Re: Administrative Site Plan Review of Process #Z2025000110

Deficiency Letter

Plans entitled “**Continental Flats**” prepared by OBRAS Studio, dated stamped received June 9, 2025; and Landscape Plans, consisting of four (4) sheets dated stamped received June 9, 2025.

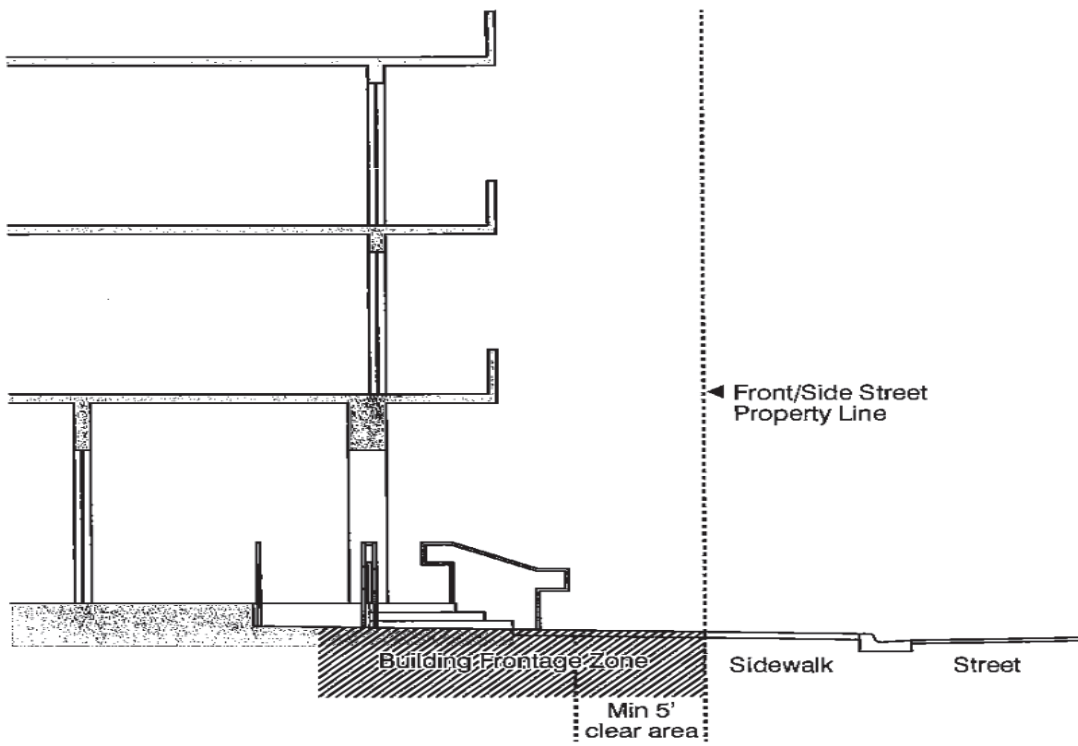
9. A minimum of 5 feet clear width within the building frontage zone shall be at the same grade as the abutting sidewalk and kept clear for pedestrians, as shown in the following diagram:
